MEMORANDUM

REVIEW TYPE: Site Plan Review
APPLYING FOR: Approval 7,800 sf Commercial Retail Space 0.76 acres

PROJECT NAME: Cloverly Commercial
CASE #: 8-03010
REVIEW BASIS: Site Plan required in the C-1 Zone [§59-C-4.341.2]

TO: Mary Beth O'Quinn, Development Review Division
VIA: Bill Barron, Community-Based Planning
FROM: Calvin Nelson, Jr., Community-Based Planning *cn*
SUBJECT: #8-03010 – Cloverly Commercial

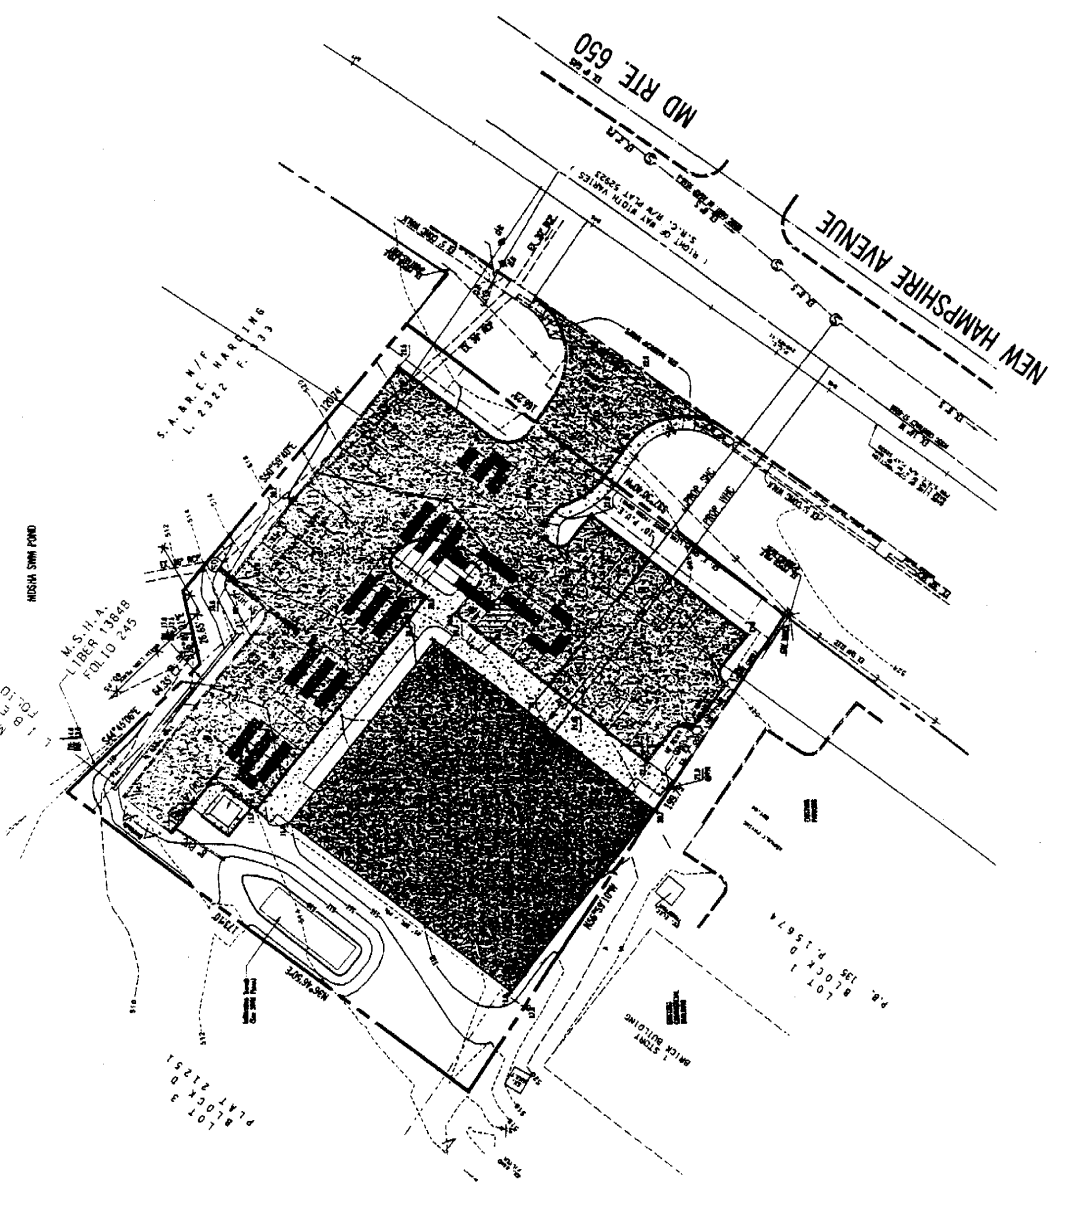
Community-Based Planning staff notes that the proposed Site Plan eliminates about a 12-foot section of sidewalk, which was shown between the front of the proposed building and parking area on the approved Preliminary Plan. Staff suggests that this sidewalk should be extended to the western property line as shown on the approved Preliminary Plan. Staff also notes that the pavement within the 20-foot wide access and utility easement stops about 10 feet short of the property line. Since this will be the sole access for the future Se-Me Hahn Presbyterian Church, the barricade and pavement should extended to the property line.
